Service Bulletin

MANADATORY WITH TCM (BENDIX) RETARD BREAKER MAGNETO INSTALLATION

TCM Starting Vibrators

Document: Service Bulletin SB-GA8-2008-49

Figure 1

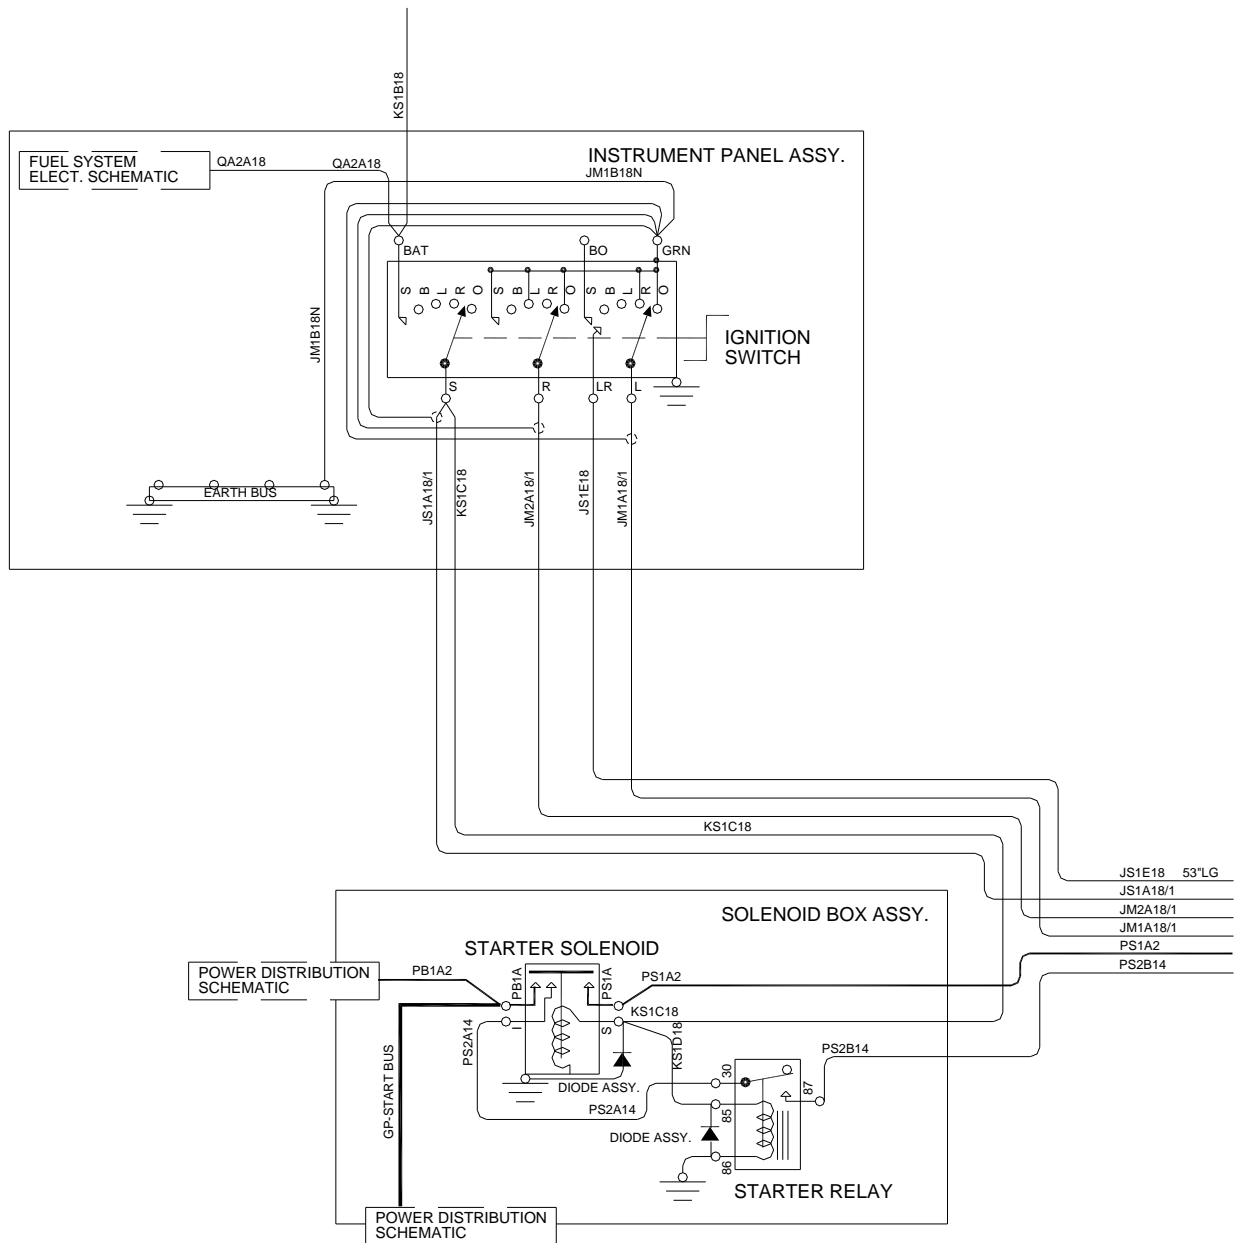
- 2.3 Remove the spade type connectors from wires JS1A18/1 and JS1C18/1 at the Slick Start end. Tie both ends of wire JS1B18/1 into the wiring loom.
- 2.4 Do not reconnect JS1B18/1 to the switch terminal on the Left magneto. Tie the earth wire JS1F22N into the wiring loom. Install wire JS1E18 as shown in Figure 1 and Figure 2.

- 2.5 Starting at the Ignition switch end feed the wire along the electrical loom through the firewall to the Left magneto. Attach the end of the wire at the ignition switch to terminal **LR**. Trim wire JS1E18 to length as required at the left magneto.

- 2.6 Install a ring crimp terminal part number RT1.25-5 and attach the wire to the retard breaker terminal
- 2.7 Install spade connectors part number FIQC1.25-4.8/.5DG on wires JS1A18/1 and JS1C18/1.
